Addendum No. 2

IFB-25-00071 Thonotosassa Fire Station #21

SOLICITATION TITLE: **Thonotosassa Fire Station #21**

L1.1

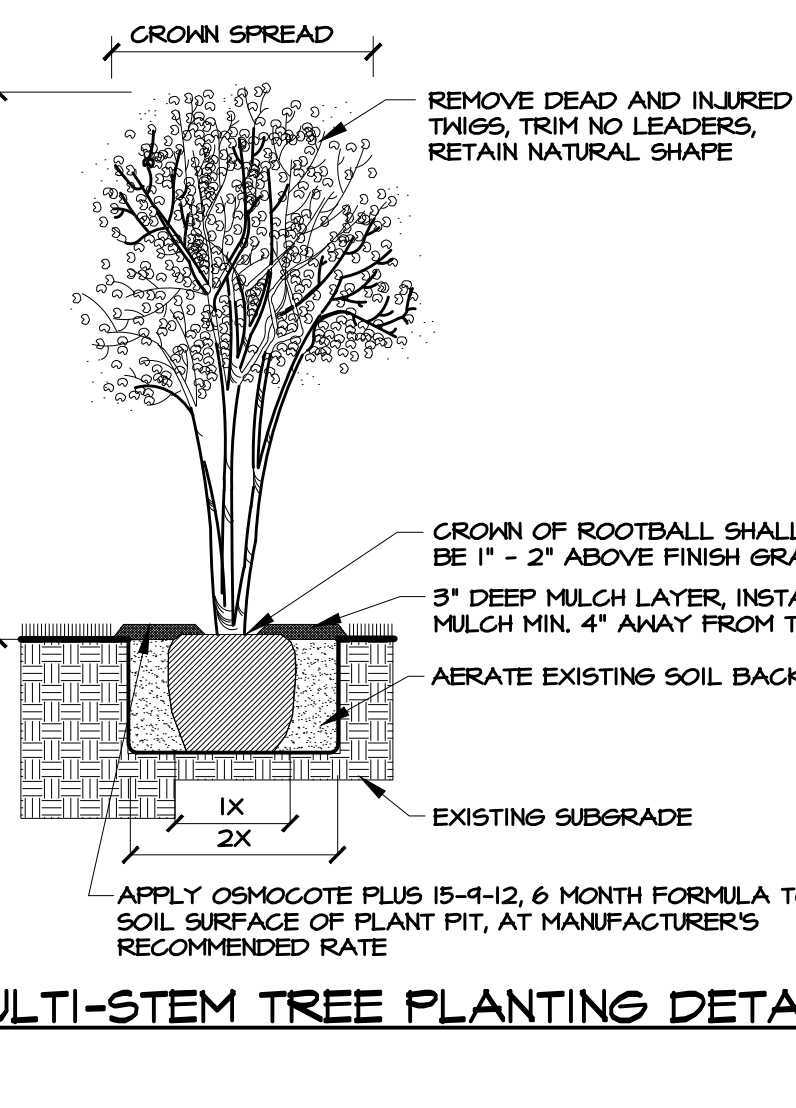
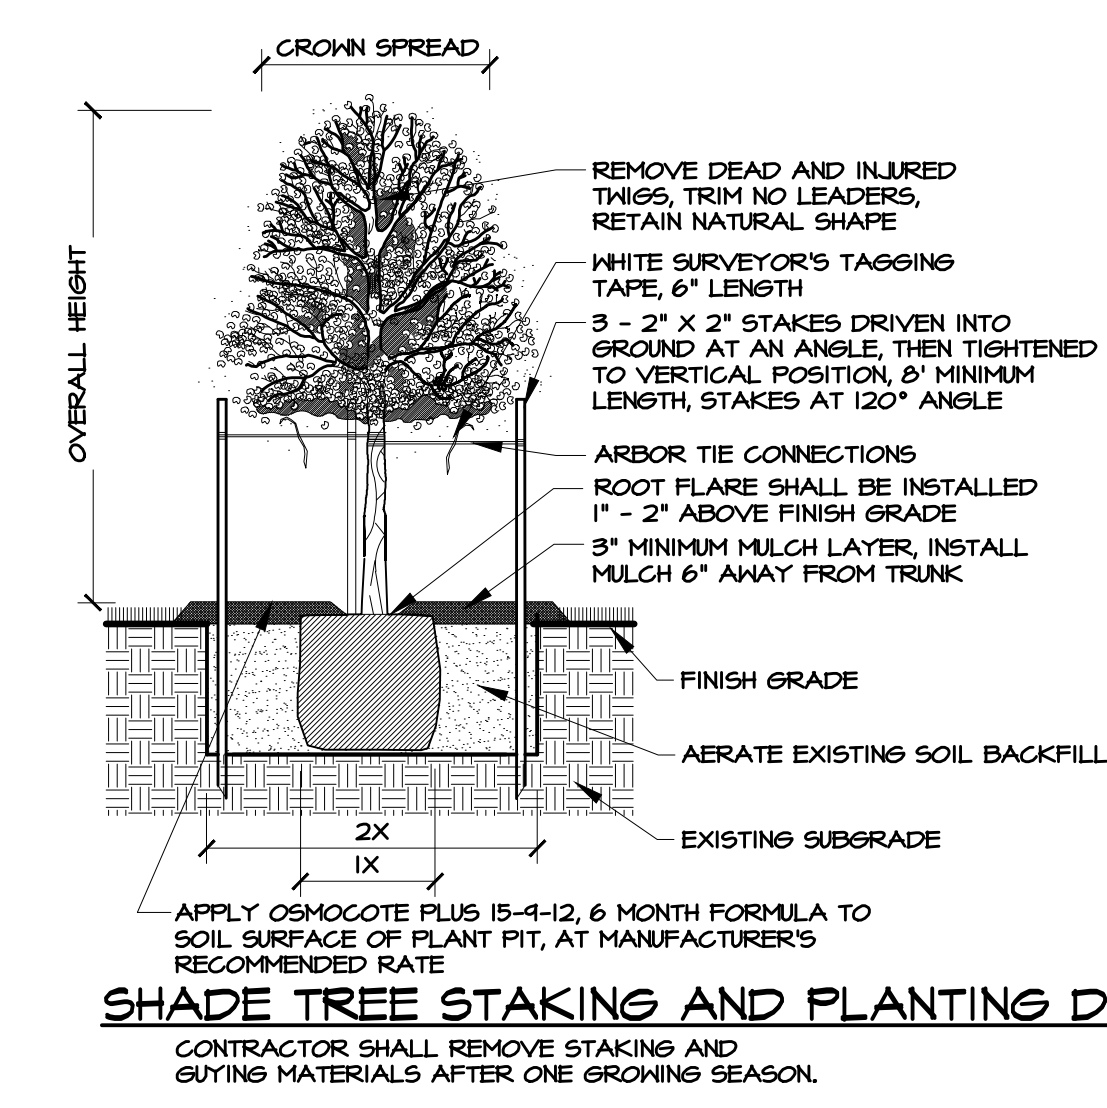
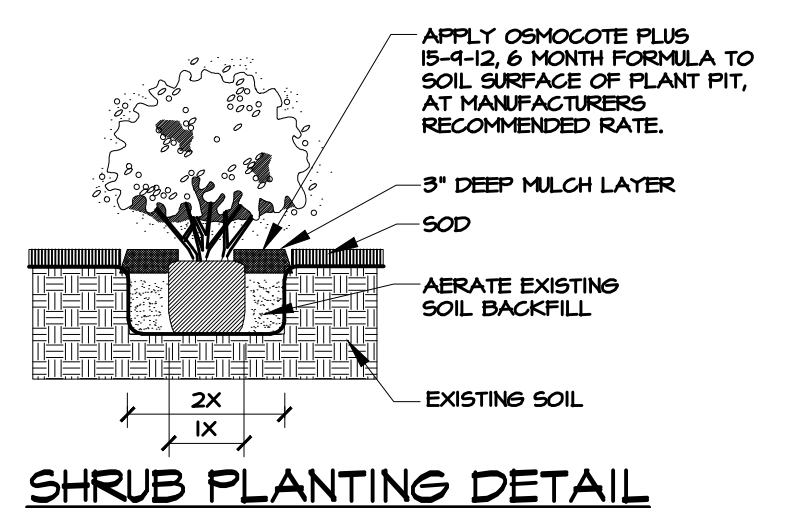
Question No.3: Please provide demarcation of the landscaping/irrigation scope of work from base bid/alternate in the landscaping/irrigation plans.

Question No.34: Alternate for secondary access drive – Bid documents indicate only the condition if the secondary access drive is to be provided and indicate the 50' extension line. Please provide a drawing for reference of what scope is to be included in the base bid and limits of work if this alternate is not accepted.

Question No.47: Provide clarification as to Alternate #6 which implies that all work associated with the secondary access drive onto CR 579 is not included in the base bid, since the description of work is not clear regarding the extent of the storm drainage, landscaping/irrigation, site lighting, sidewalk and fencing configuration along CR 579, etc. that is to be included in the base bid. Provide drawings clearly showing the storm drainage, landscaping, fencing, sidewalks and electrical that is to be included in the base bid.

Response: See attached revised landscape plans showing Base Bid and Alternate #6.

Response: Refer to civil drawing sheet C-4.1 and attached revised Landscape plans showing Base Bid and Alternate #6.

Response: See Landscape Plan and Irrigation Plan with Addendum 02 for Base Bid and Alternate #6 work limits.

A1.6

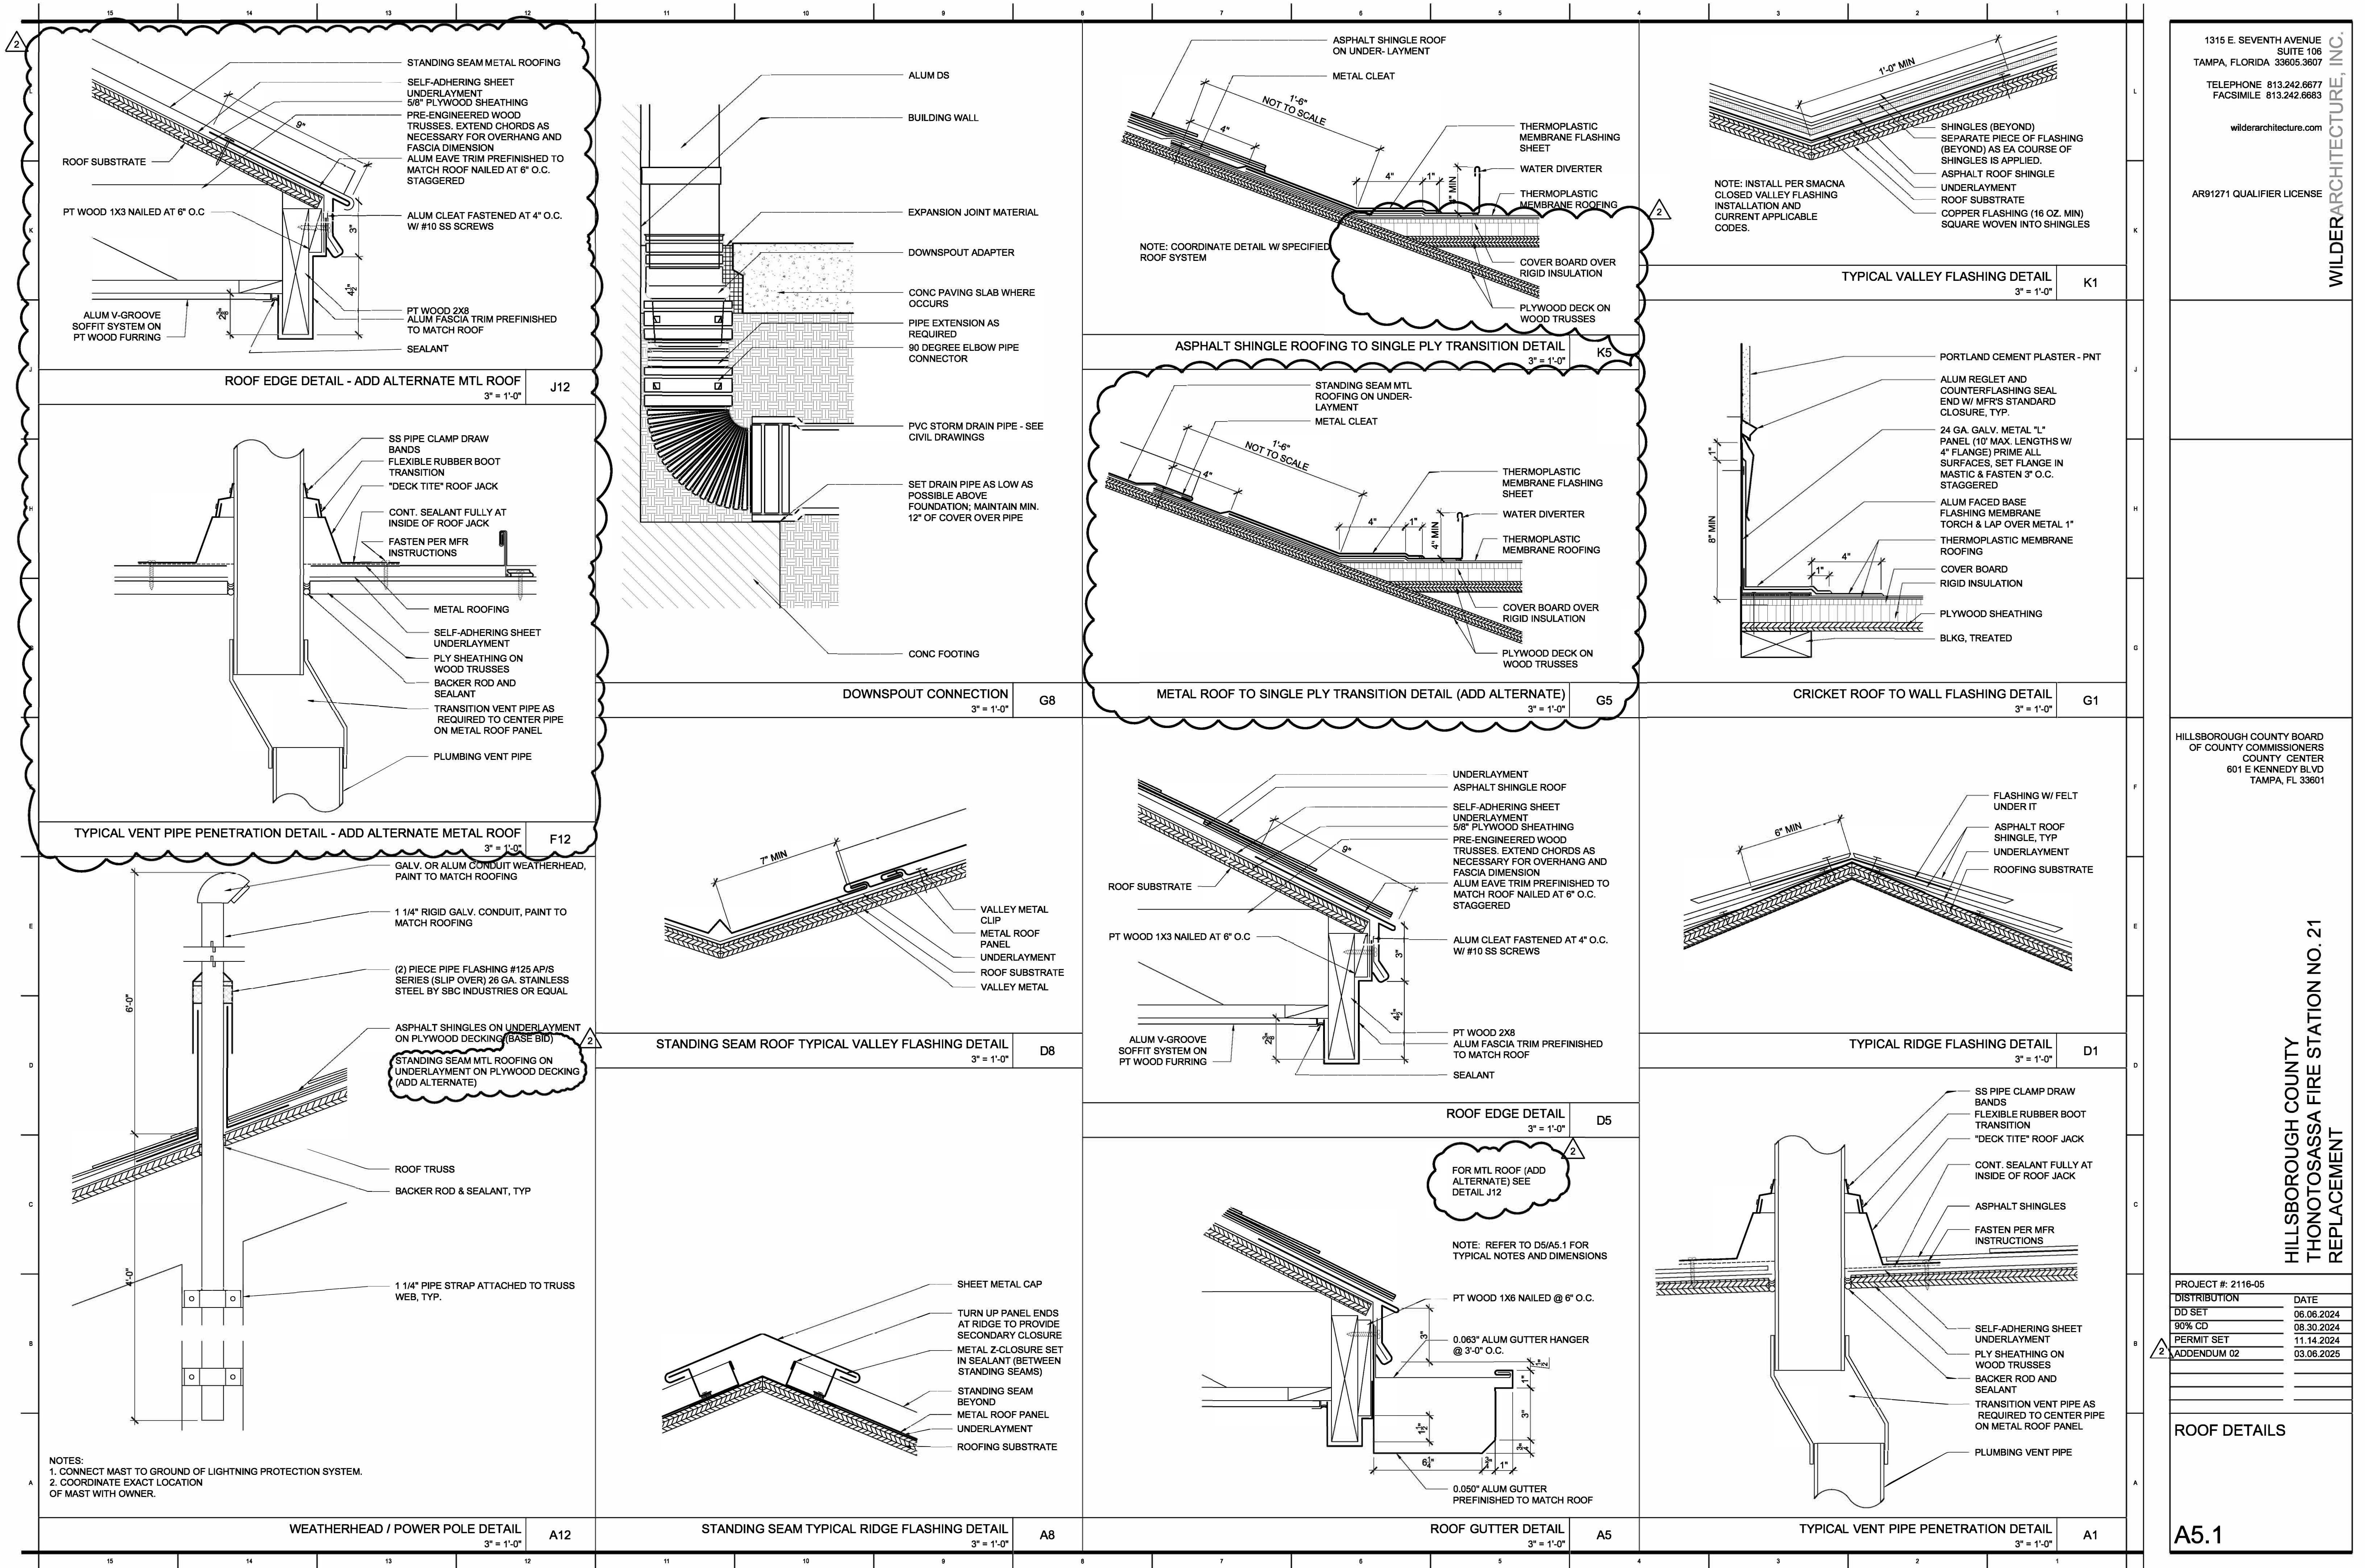
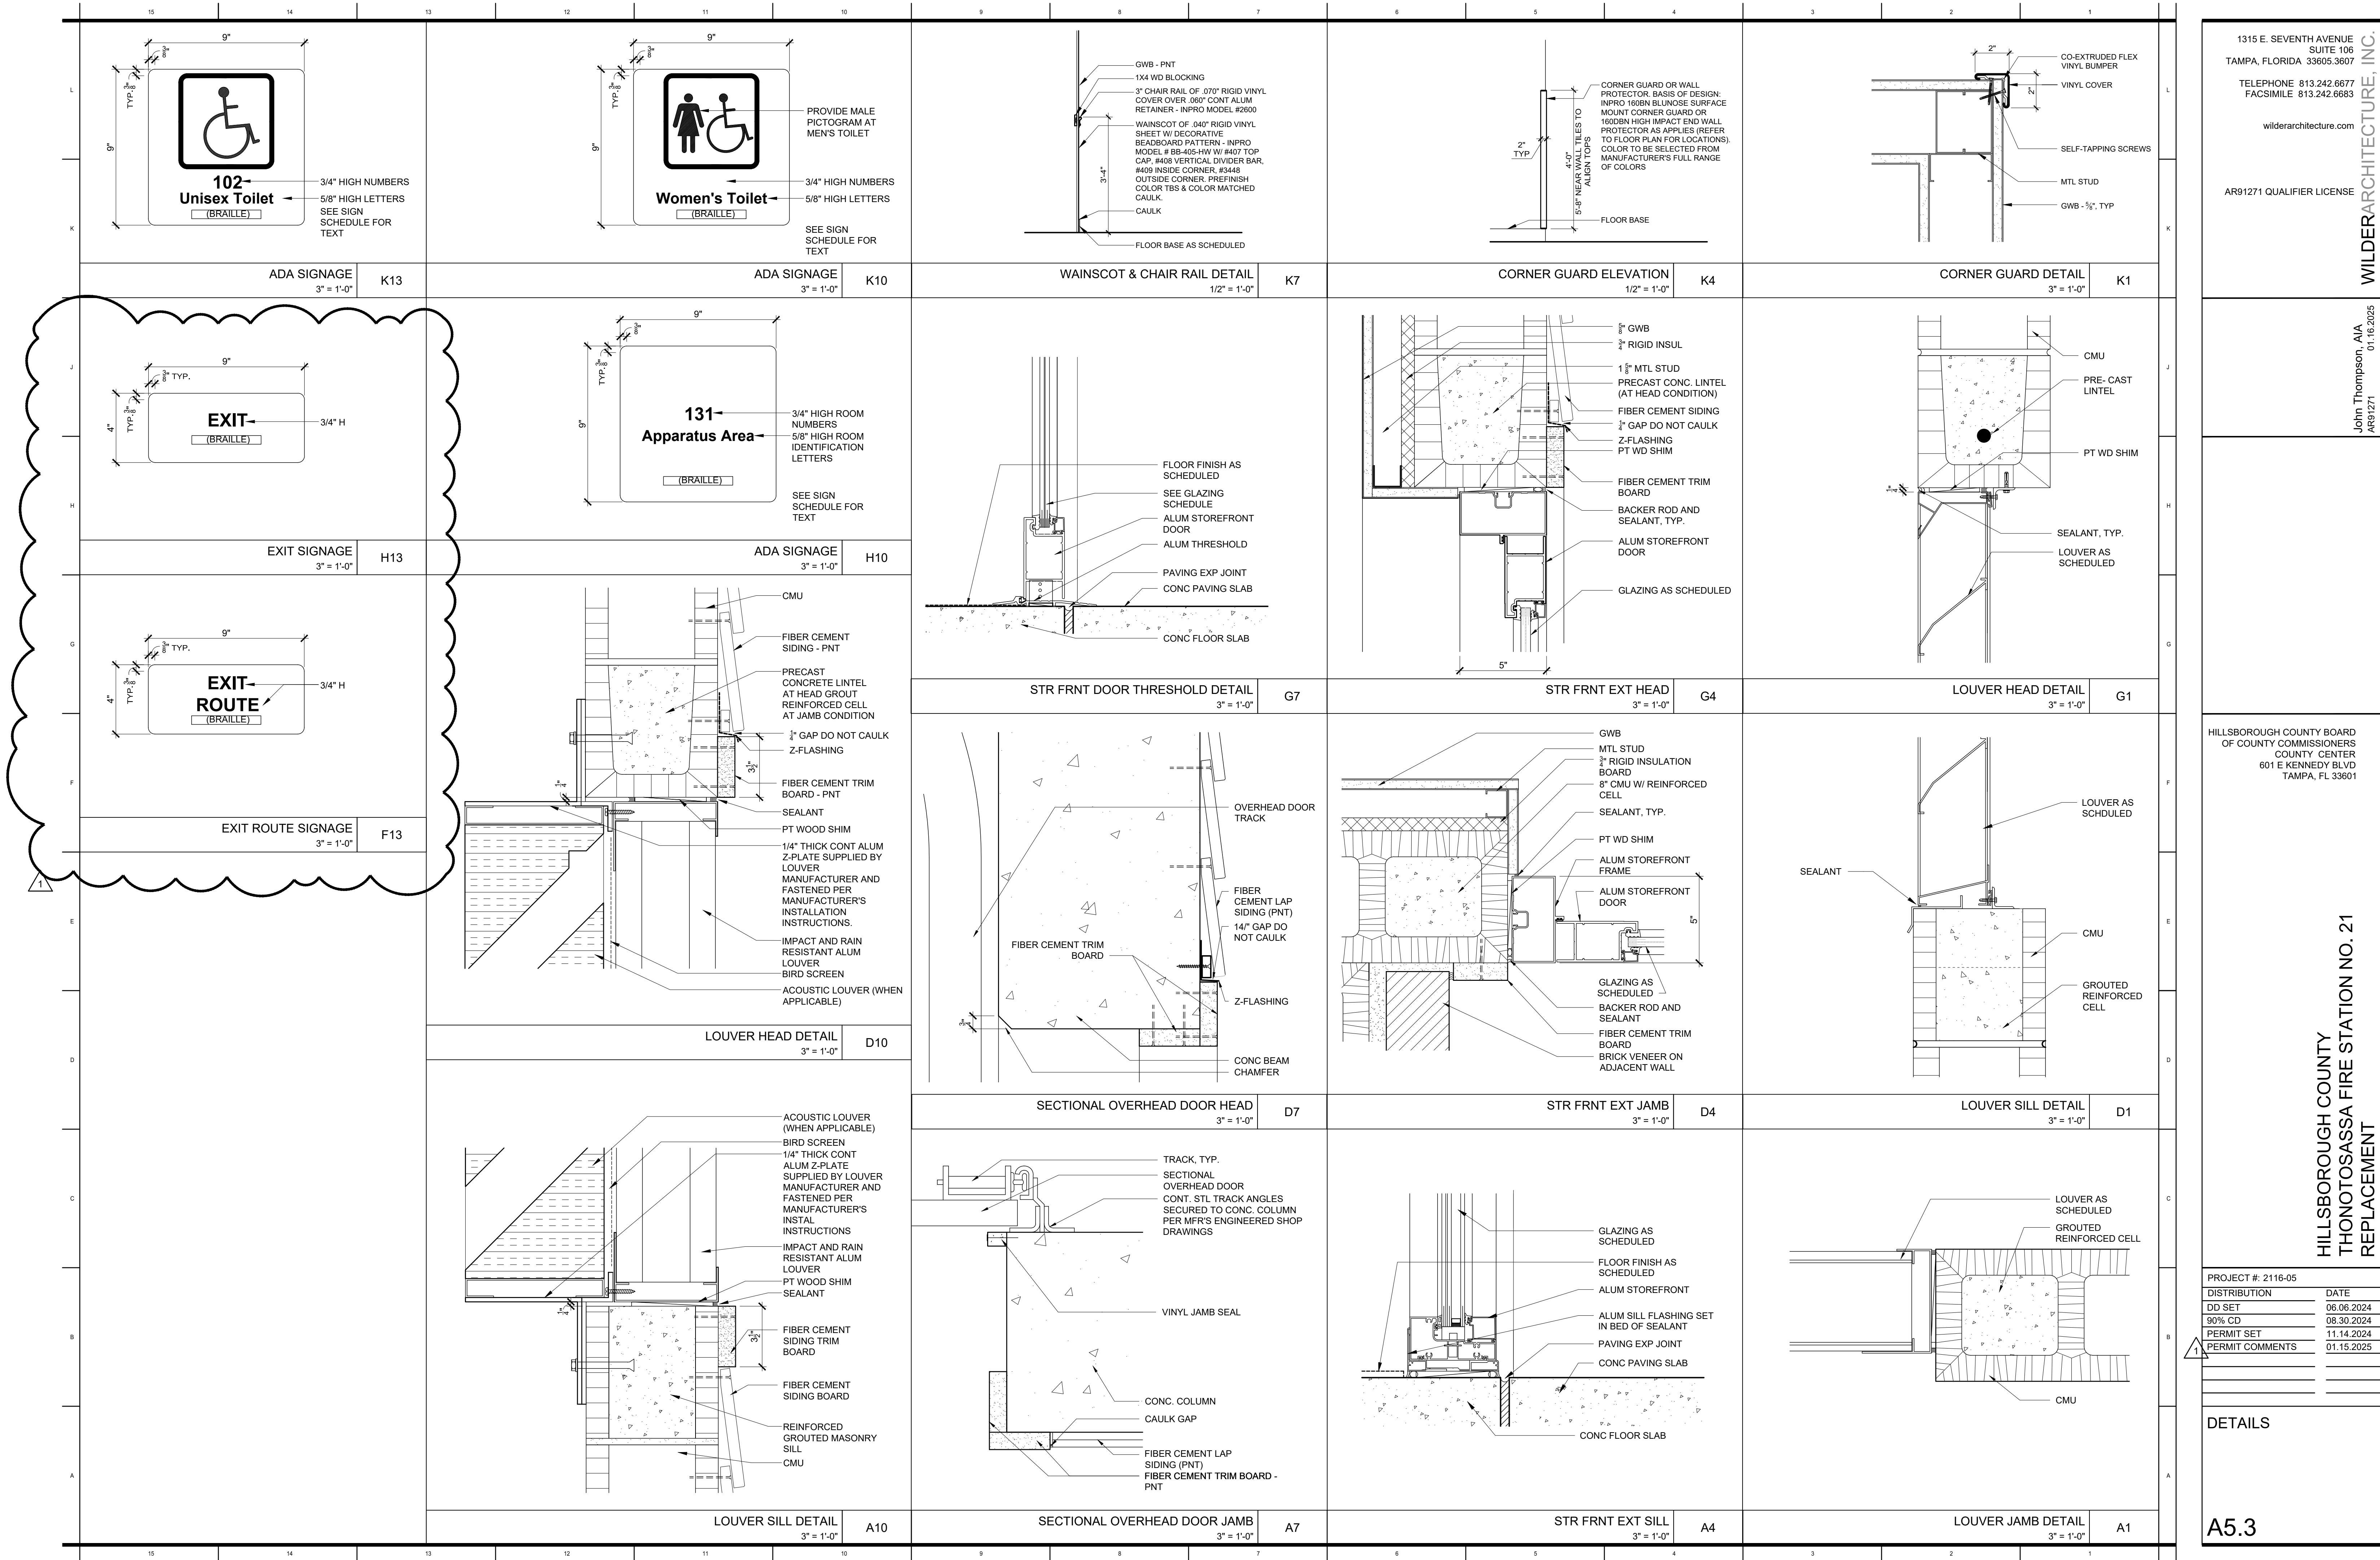
Question No.31: Reference sheets A1.0 & A1.2. The detail of the oxygen tank storage shed shows a 1:12 pitch shingle roof, however a shingle roof cannot have a 1:12 pitch. As shown on the roof plan for the main building, the cricket roof with a 1:12 pitch is shown to be TPO membrane roofing. The storage shed would also be assumed to be TPO membrane or a metal roofing system. Please advise.

Response: Oxygen tank storage roof system to match the main building. If asphalt shingles provide a pitch of 2:12, if Bid alternate No. 5 Metal standing seams roof gets approved keep the 1:12 pitch for the storage. Adjust slope as required for the selected roof system.
